MONTGOMERY COUNTY HISTORIC PRESERVATION COMMISSION
STAFF REPORT

Address:	3944 Baltimore Street, Kensington	Meeting Date:	3/23/2022
Resource:	Primary Resource Kensington Historic District	Report Date:	3/16/2022
Applicant:	Meredith Sharp	Public Notice:	3/9/2022
Review:	HAWP	Staff:	Dan Bruechert
Case Number:	897942 (Amended)	Tax Credit:	n/a
Proposal:	Revision – Building addition, fenestration, other details to previously approved HAWP.

The applicant proposes revisions to fenestration, stairs, the addition of skylights, and change in siding details on the building addition.

Figure 2: Drawing A001.

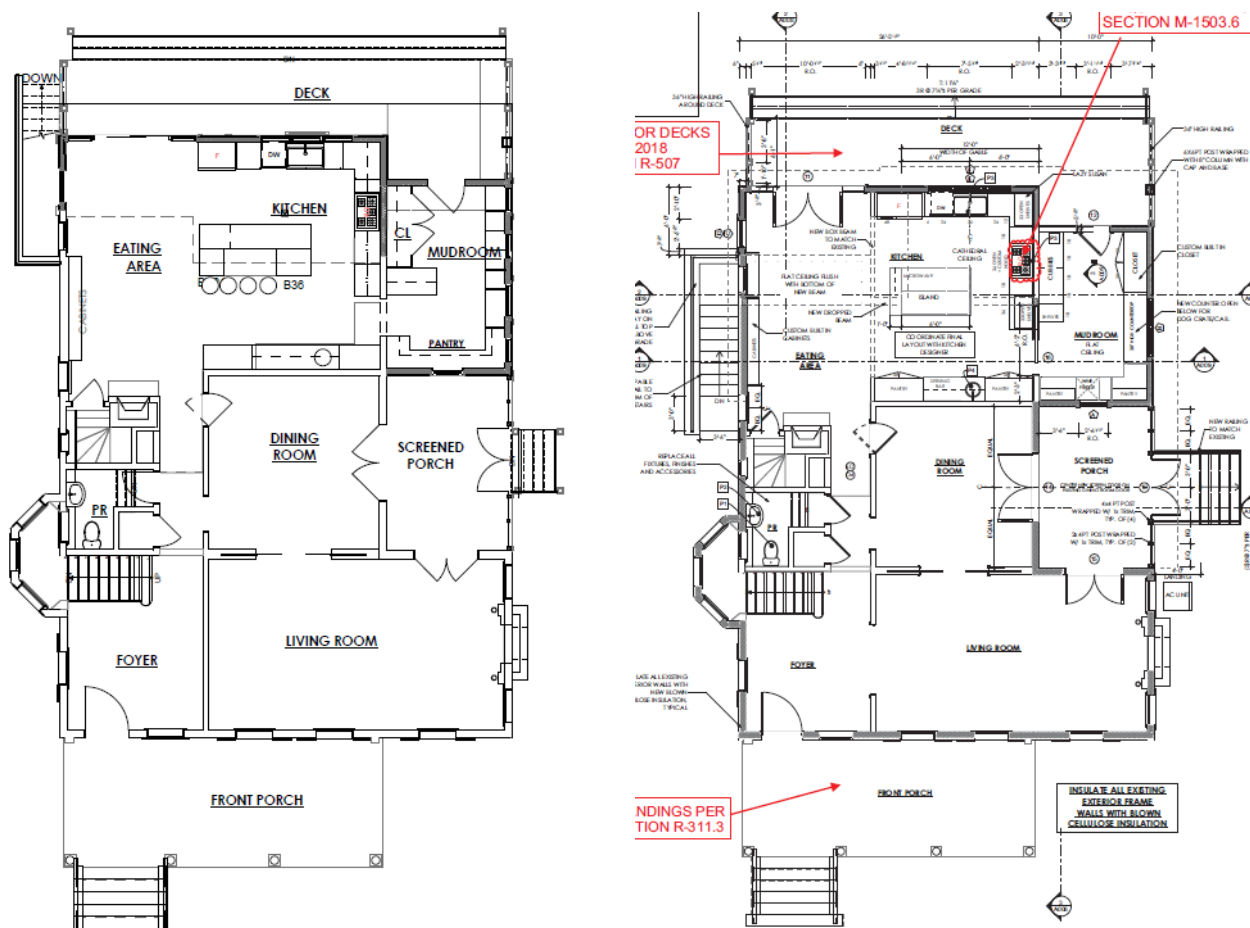
There are two changes shown on page A001 (the approved drawing is below to the left, and the revised is shown on the right). First, the exterior basement stair run shown in the previous submission has them loading from the rear. The revision, shows them loading from the front. There are no changes in materials or dimensions, only the direction of the stair run. Staff finds that this change will not have a significant impact on the character of the house or the surrounding district.

The second change shown on A001, is the approved sliding glass doors have been replaced with a pair of aluminum-clad wood doors with sidelights. This change is primarily one of door operation because the dimensions and materials of the door and sidelites are unchanged from the previous approval. As this change is at the rear of the approved addition, Staff finds it will not impact the character of the house or surrounding district and should be approved as a matter of course.

Figure 6: Drawing A006.

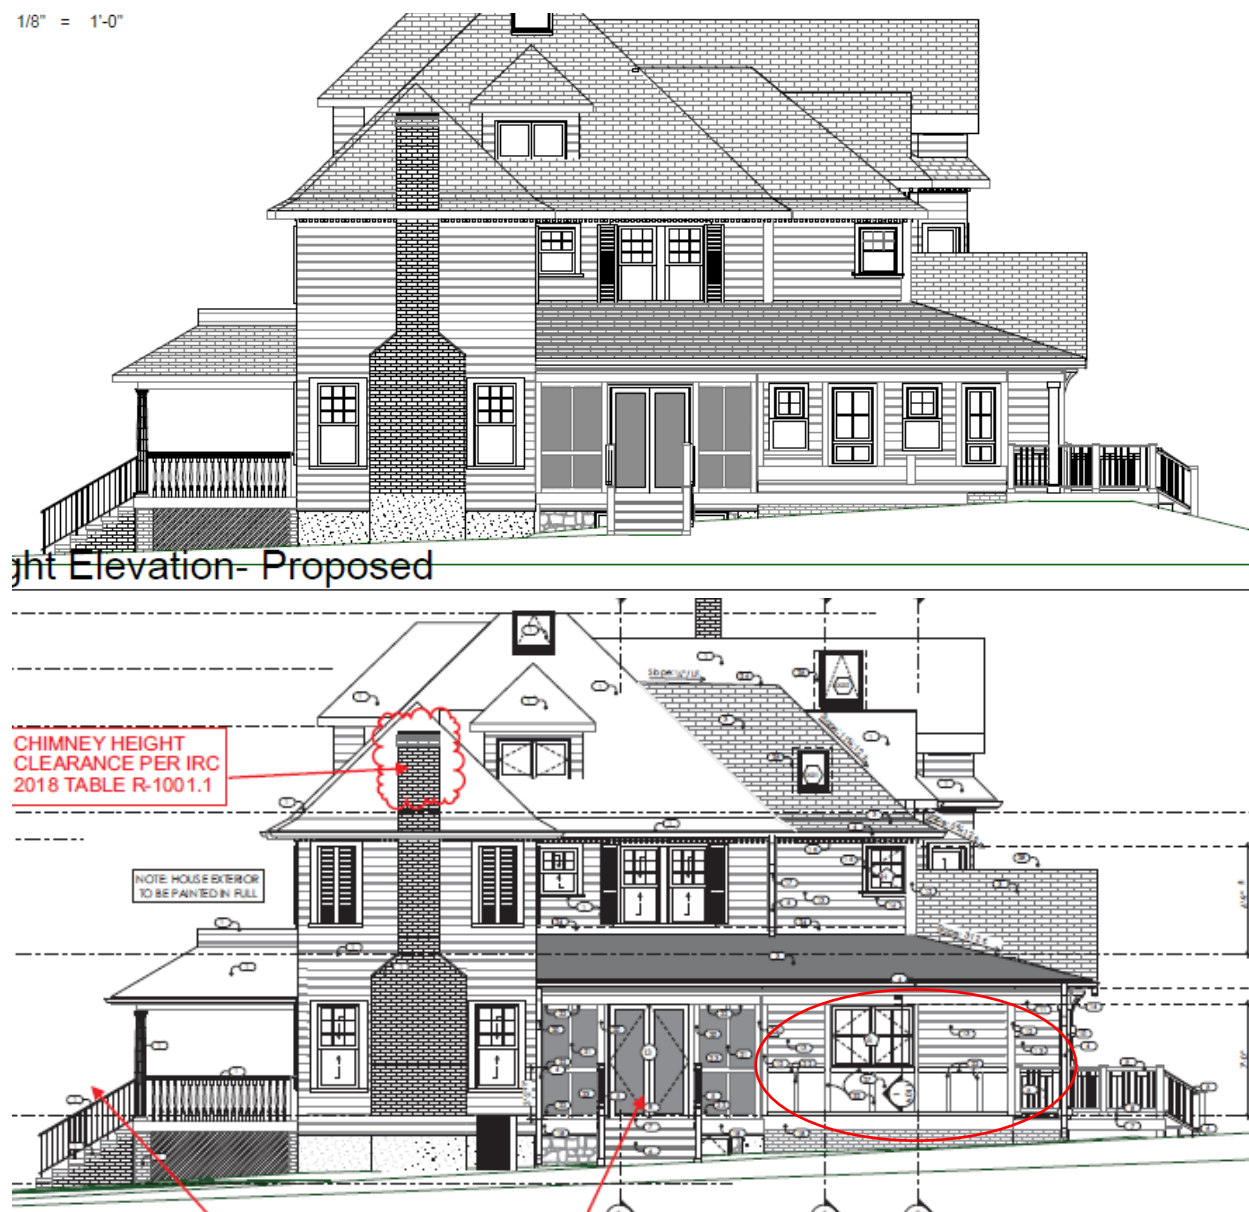
On the right elevation, the applicant proposes to change the fenestration in two locations. First, the applicant proposes to change a 6/1 sash window to a nine-lite casement. This change is minor and is consistent with the alteration proposed for the rear addition, discussed above. Staff finds this alteration will have a minimal impact on the character of the house or surrounding district and recommends approval.

The second change proposed on the right elevation is the fenestration on the first floor. Instead of the approved two fixed and two casement windows, the applicant proposes to install a pair of four-lite casement windows over smooth siding that will match the siding proposed for the rear. The clad wood windows will match the other windows approved for the rear of the house and due to its placement at the rear of the right elevation, the proposed window will not be visible from the public right-of-way. Staff finds these changes will not impact the character of the house or surrounding district and recommends the HPC approve the changes.

Figure 3: Drawing A003.

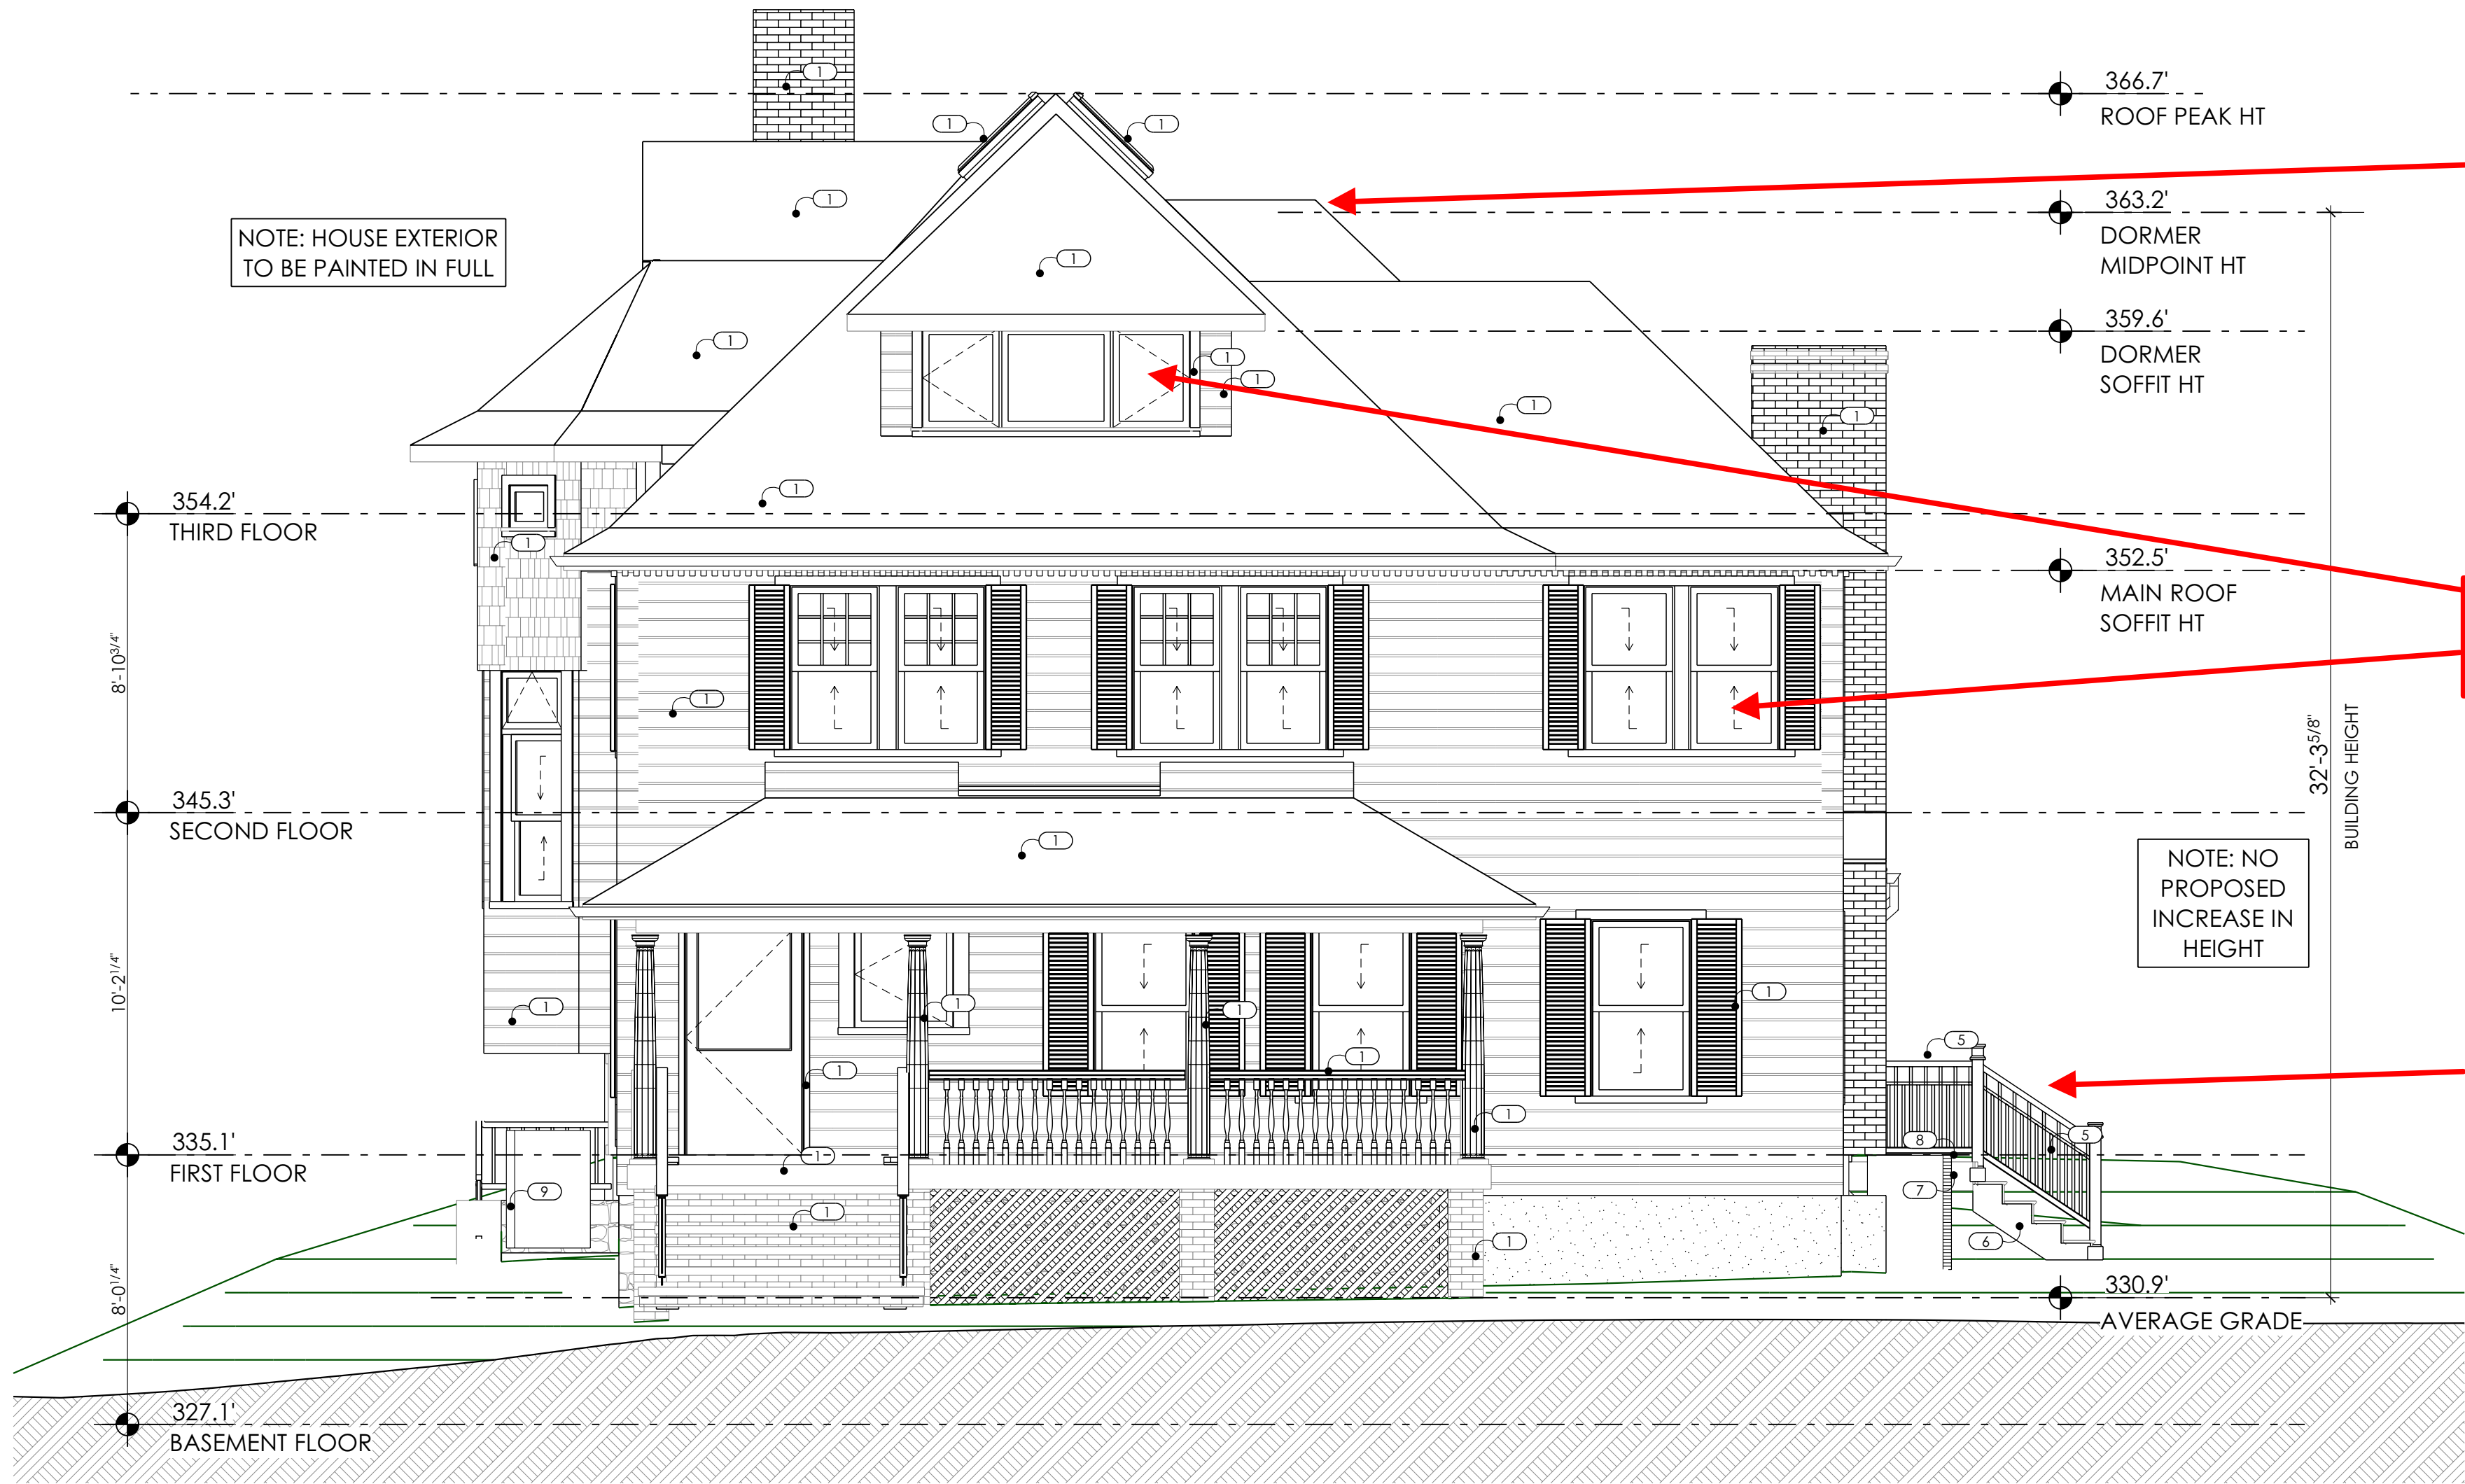
The proposed roof plan shows the introduction of two new skylights on the new addition. The drawing from the approved HAWP are shown below on the left, and the revised are shown on the right. These skylights match the materials of the three existing skylights and will be installed at the rear of the approved addition. Staff finds these new skylights will be minimally visible from the surrounding right-of-way and will not impact the historic design or fabric of the historic resource.

Figure 4: Drawing A004.

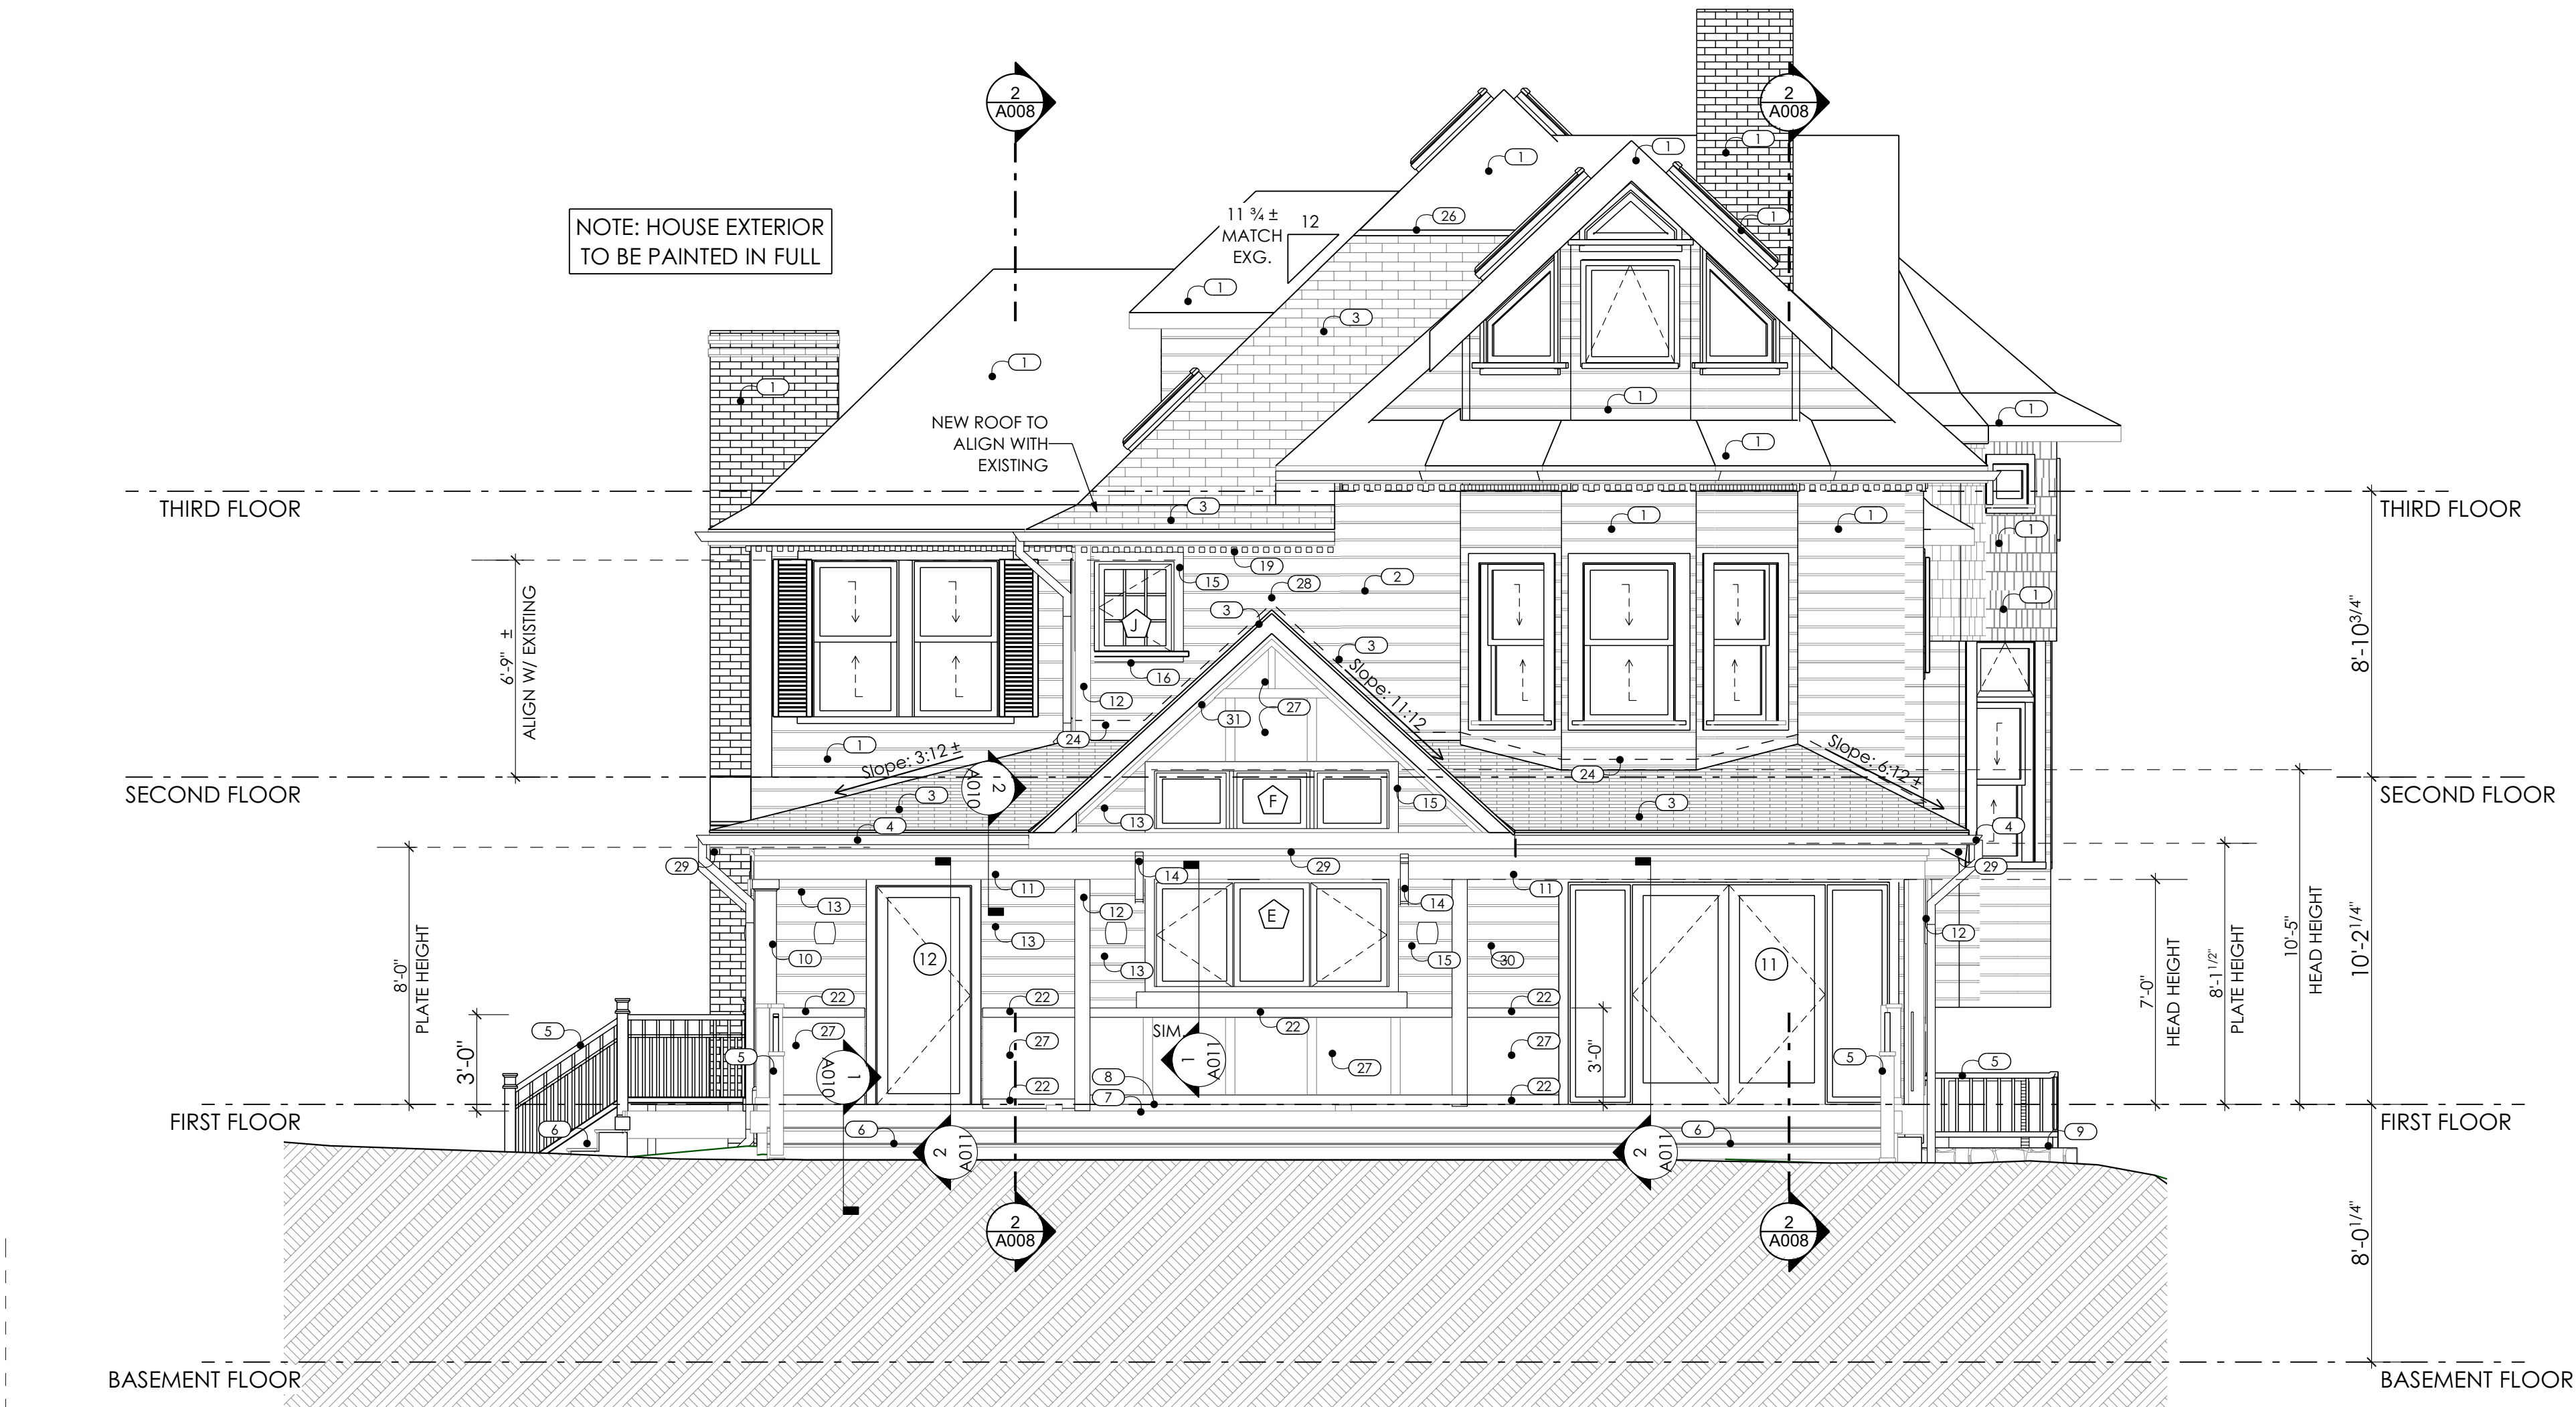
On the right side of the proposed addition, the applicant proposes to add a landing at the top of the stairs. This has the effect of projecting the stairs further out from the historic wall plane by 4' (four feet). Staff finds that this change will be slightly visible from the public right-of-way, but will not detract from the historic character of the house or the surrounding district. Other changes to the right elevation are detailed on sheet A006, discussed below.
